Clocks

July 2023

LMK04828

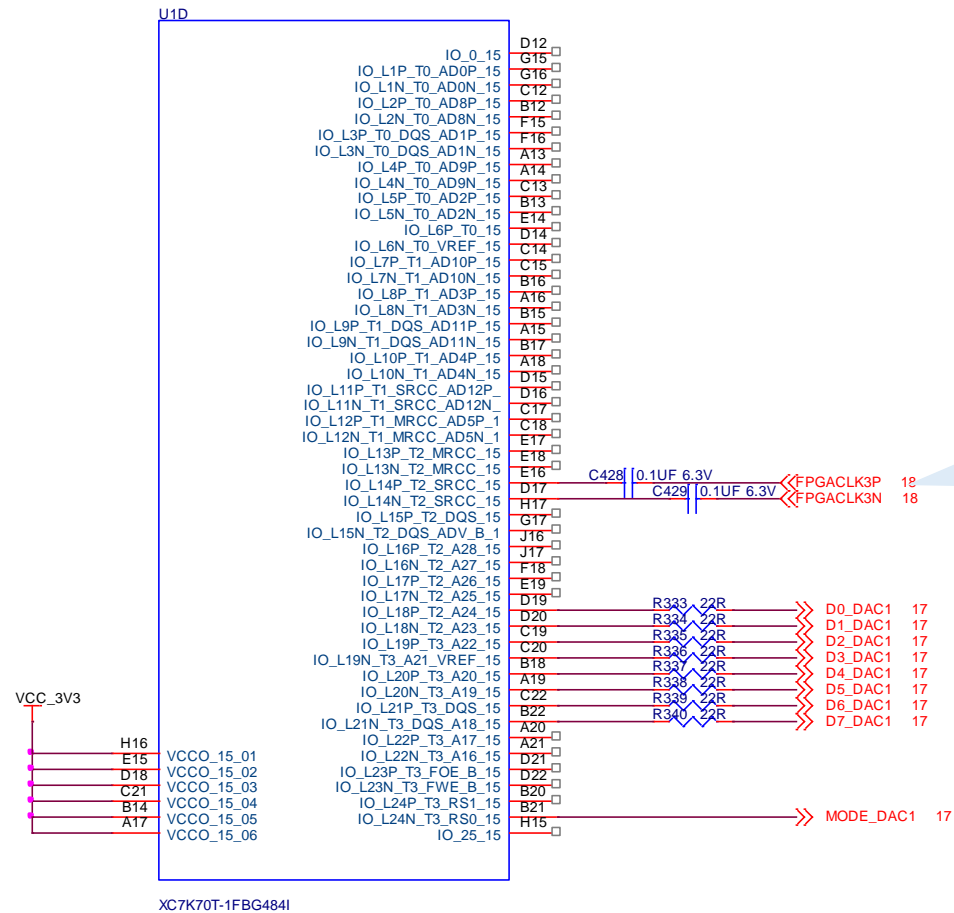
I think I need to change to LVDS (see Slide 5 for ADC). Should I remove R414 and R415?

I think I need to change to LVDS (see Slide 5 for ADC). Should I replace R418 and R419 with 0 Ohm?

ADC32J25IRGZT

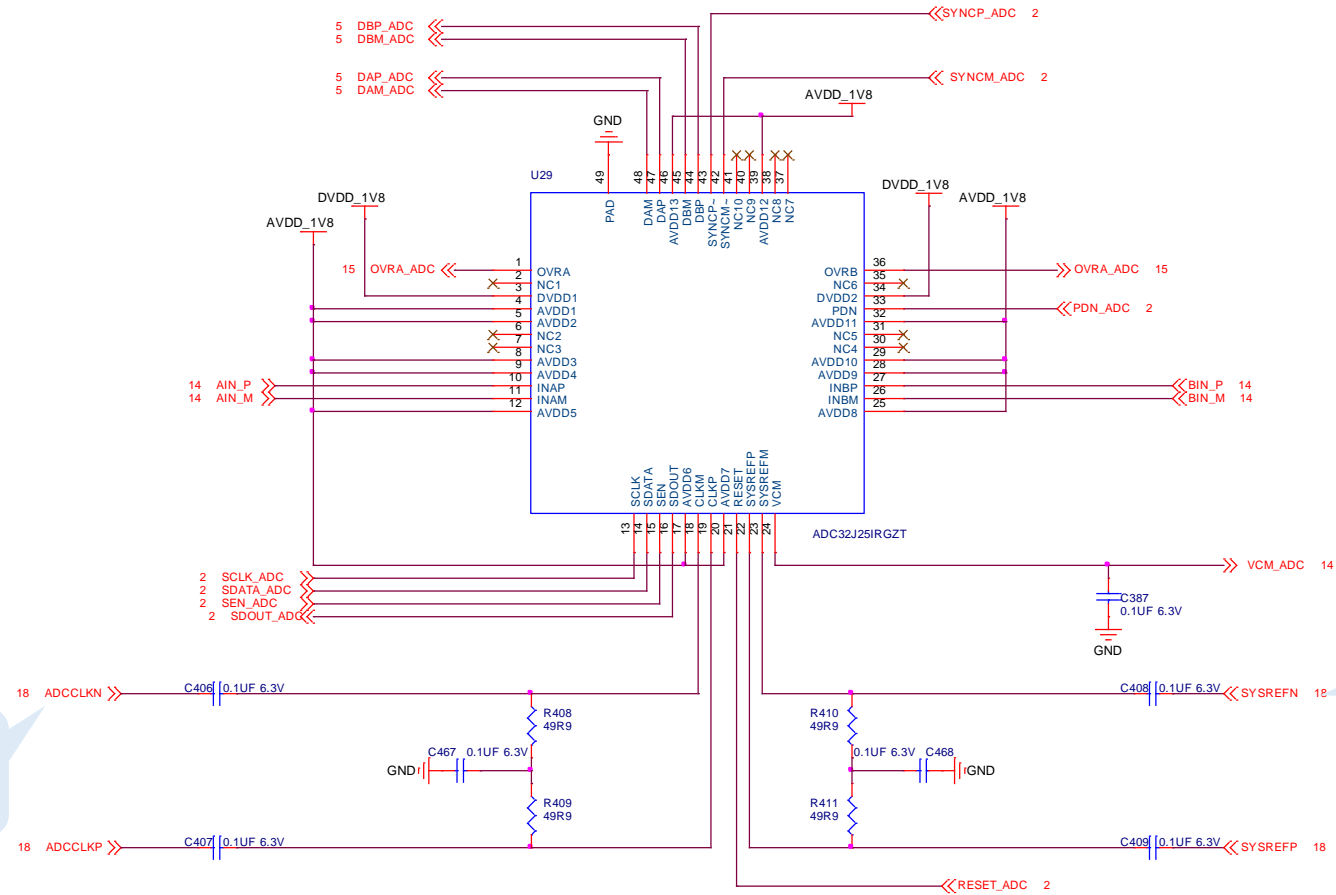
Does this assume LVDS?

Does this assume LVDS?
